Proposed Revisions to a Standard Plans Index

Index Number: 654-001

Index Title: Rectangular Rapid Flashing Beacon Assembly

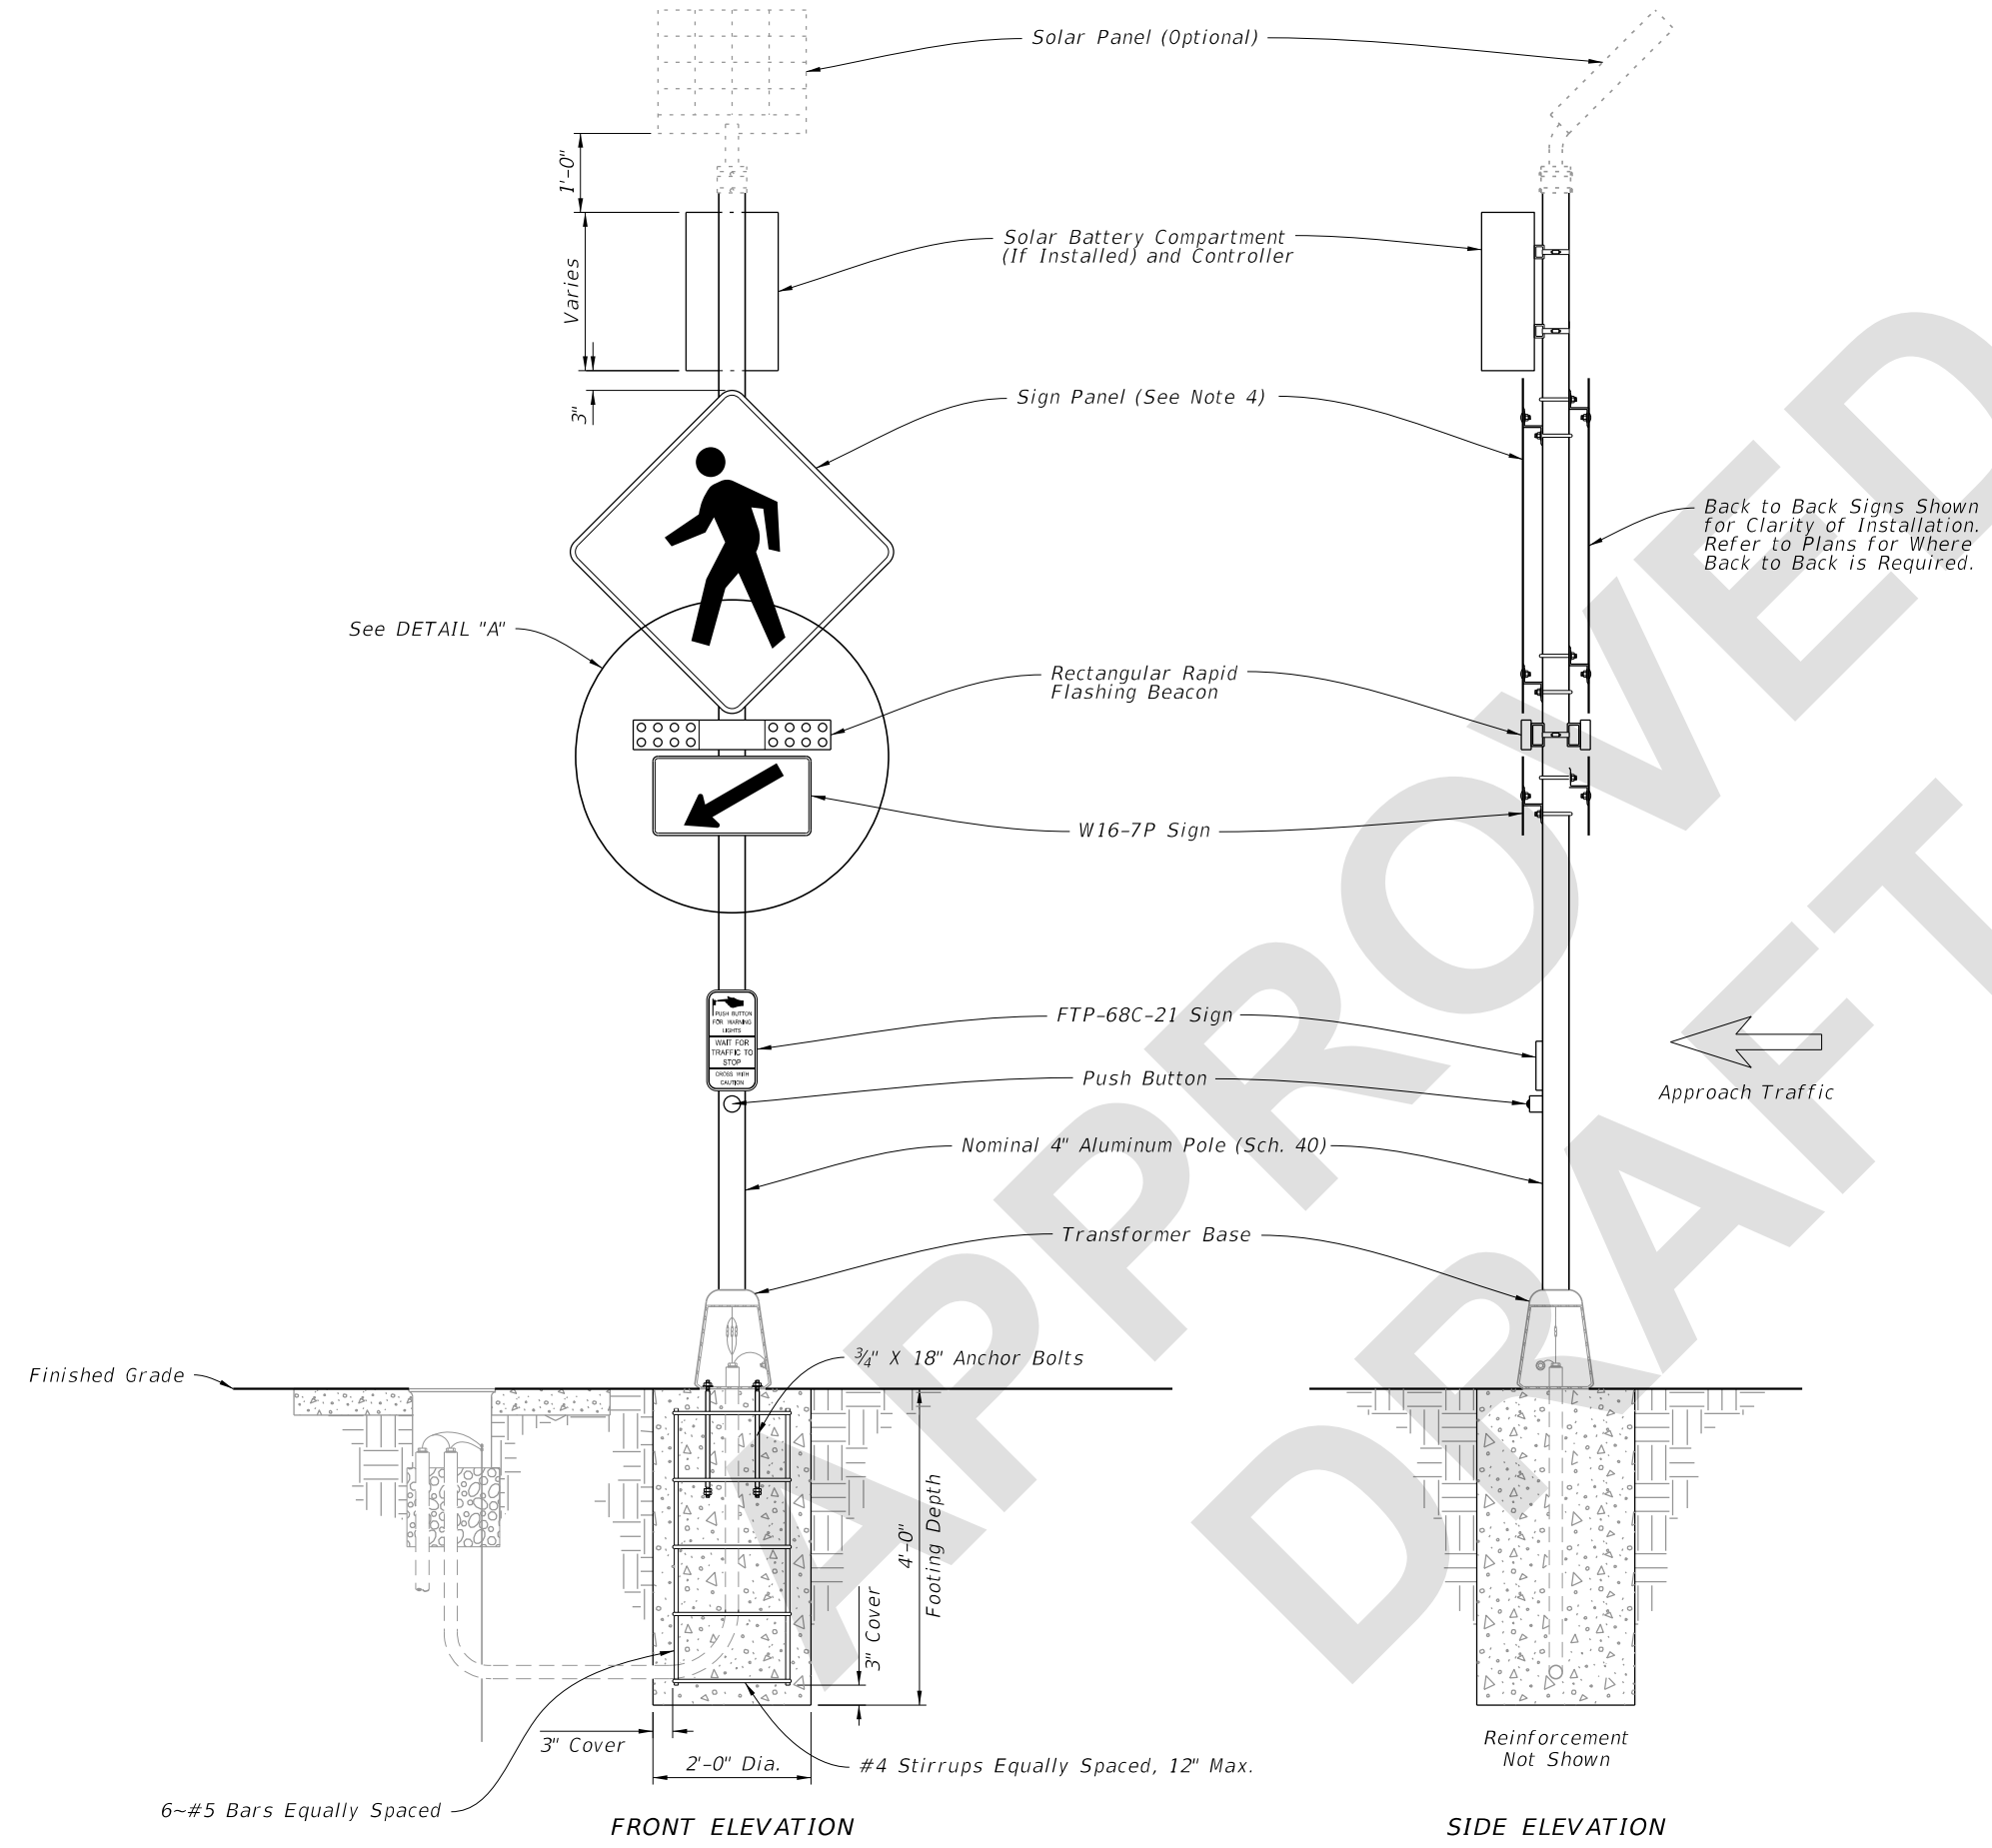
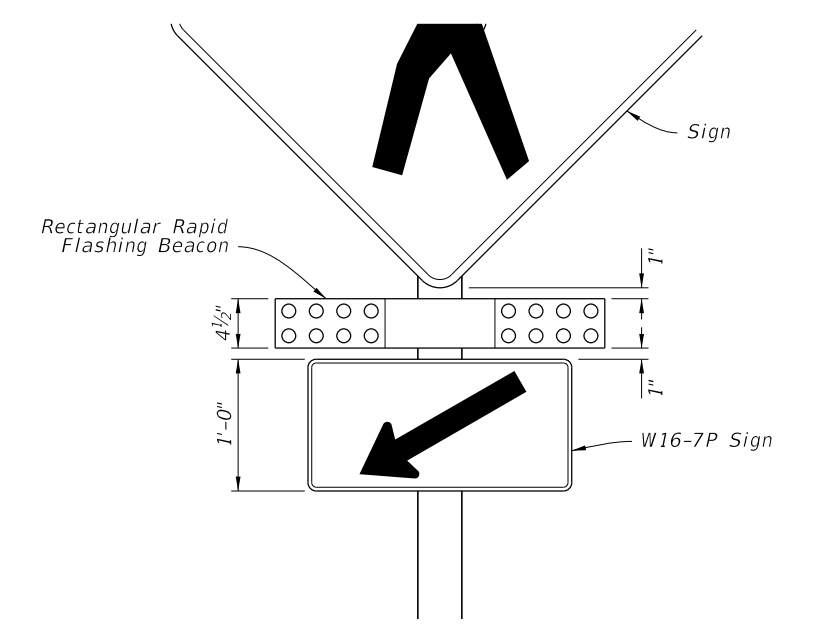
2. Install the RRFB in pairs, one on either side of approach traffic.
 3. Install controller on the backside of post from approach traffic.
 4. W11-2 sign panel shown, others similar. Use 30" X 30" sign panels for two-lane roadways and 36" X 36" sign panels on multilane roadways.

12. In lieu of footing design shown, a Spread Footing may be used in accordance with Index 700-120.

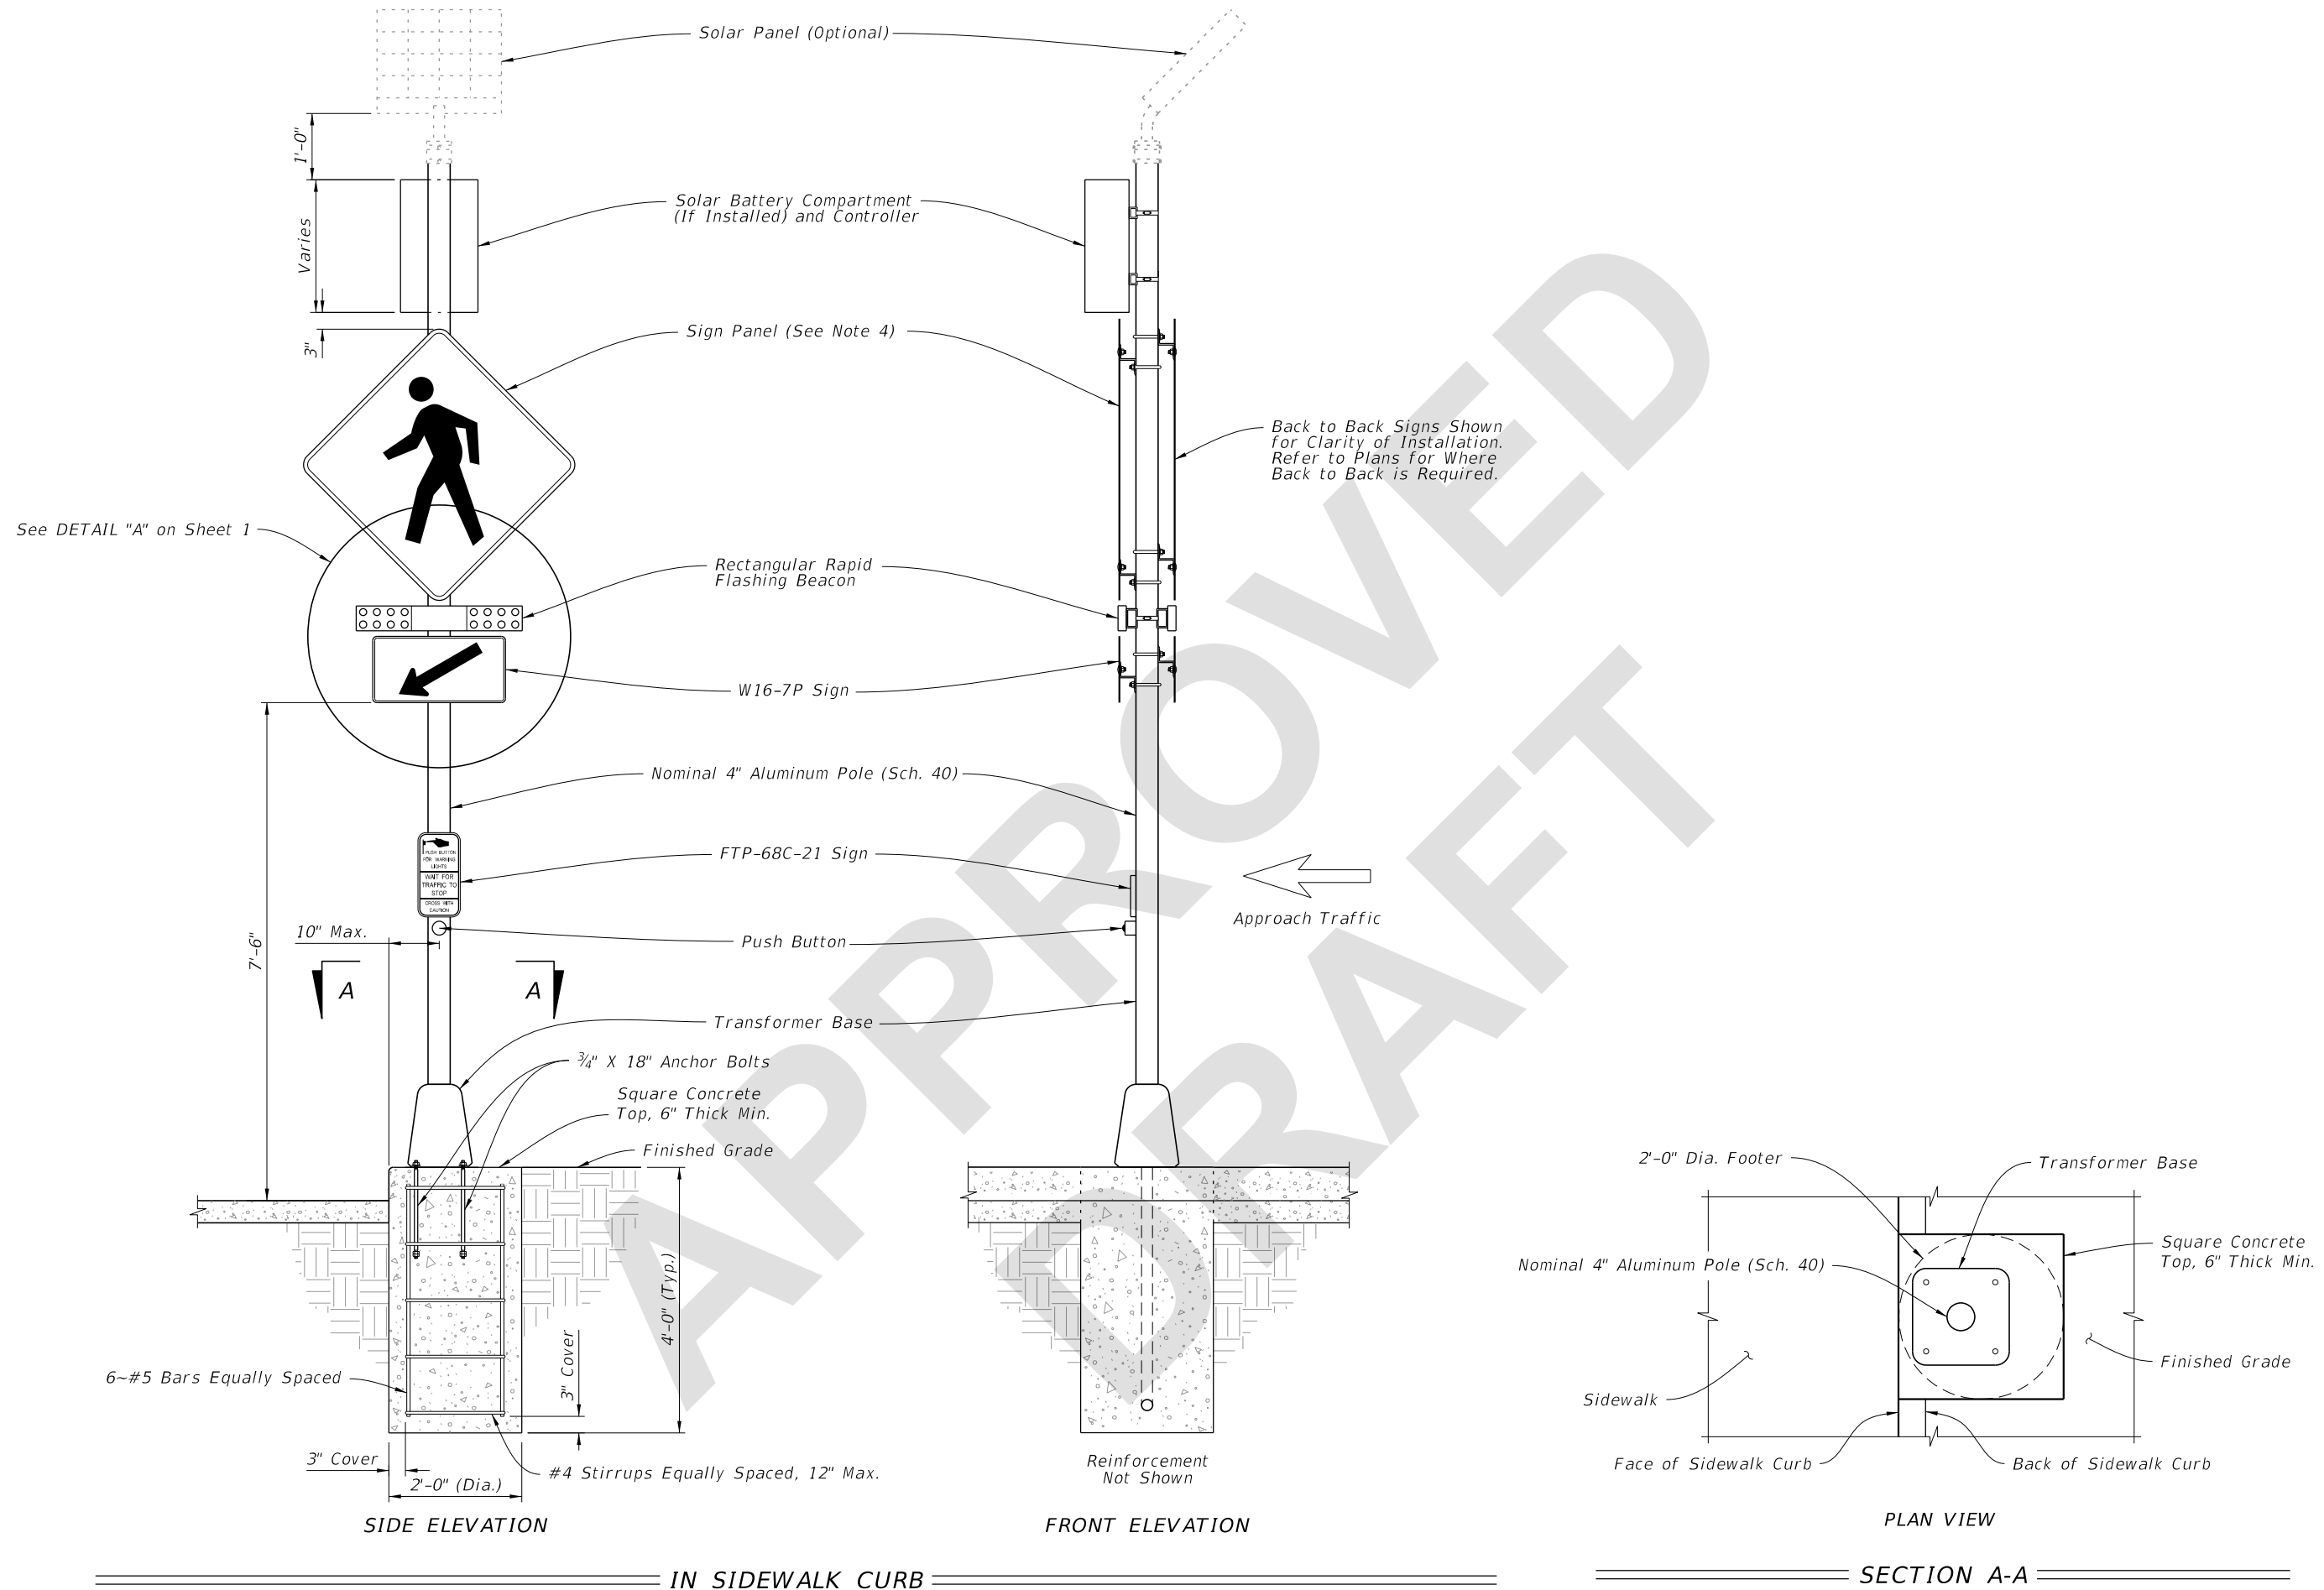
Sheet 2: Updated callout to "Sign Panel (See Note 4)".
